SERVICE BULLETIN

Handle Replacement Service Group 49085

170230

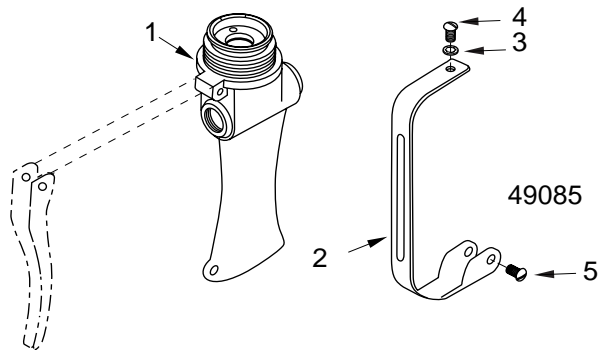
Service Part 170230 Handle is being replaced by Service Group Part 49085

Note: This new style handle now has O-ring style pressure and return porting.

49085
